Access Compliance Report

Public Rights-of-Way

(Curb Ramps)

Intersection ID: 24400	Main Street: FRESHWELL_RD	Cross Street: POPPLETON_CT	Location:	NE
ADA ID: A145E49E50C7	Ramp Type: PerpDiag	Initial Pass/Fail: Pass	Overall Compliance: No	Severity Score: 10
Codes/Mitigation Info/Possible Solution		Field Measurements/Component Compliance

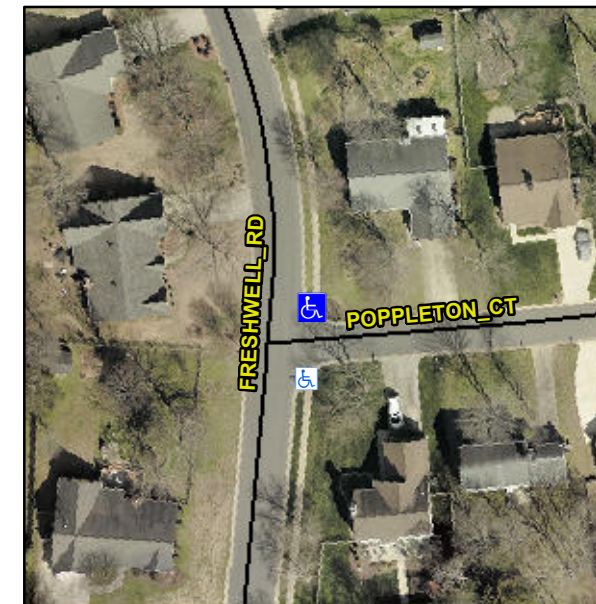
Not Found, R304.2.1, R304.2.2-Perp, R304.3.2-Para, R304.5.3, R305.2

Compliance	Description	Data	Compliance	Description	Data
N/A	Ramp Length (in)	44.5	Yes	Ramp Slope (%)	6.9
Yes	Ramp Width (in)	48.0	Yes	Ramp XSlope (%)	2.0
N/A	Flare Type LT	Sloped	N/A	Flare Type RT	N/A
N/A	Flare Slope LT (%)	0.1	N/A	Flare Slope RT (%)	3.5
N/A	Flare Traversable LT?	Yes	N/A	Flare Traversable RT?	No
No	Landing Length (in)	N/A	Yes	DWS Provided?	Yes
No	Landing Width (in)	N/A	Yes	DWS Contrast?	Yes
No	Landing Slope (%)	N/A	Yes	DWS Length (in)	24.0
No	Landing X Slope (%)	N/A	Yes	DWS Full Width?	Yes
N/A	Landing Curb? (Y/N)	No	No	DWS Offset (in)	3.0
N/A	Shared Landing?	No			
Yes	Gutter Ponding?	No	Yes	Gutter Slope (%)	1.5
Yes	Gutter Lip Ht (in)	0.0	Yes	Gutter X Slope (%)	1.7
N/A	Painted X Walk1?	No	N/A	Painted X Walk2?	No
	X Walk 1 Direction	To W		X Walk 2 Direction	To S
N/A	X Walk 1 Width (in)	N/A	N/A	X Walk 2 Width (in)	N/A
	X Walk 1 Slope (%)	6.9		X Walk 2 Slope (%)	4.0
	X Walk 1 X Slope (%)	2.7		X Walk 2 X Slope (%)	1.1

N/A	Ramp inside XWalk1?	N/A	N/A	Ramp inside XWalk2?	N/A
	Road Slope (%)	1.9	N/A	Clear Space?	Yes
	Road X Slope (%)	4.0	N/A	Clear Space to XWalk (in)	N/A
Yes	Any Obstructions?	No	Yes	Storm Grate/Utility Hazard?	No
	Obstruction Type			Storm Grate/Utility Type	
		N/A			N/A
			Yes	Surface Condition? (G/P)	Good

Remove & Replace Curb Ramp With Two New Directional Ramps or Equivalent.
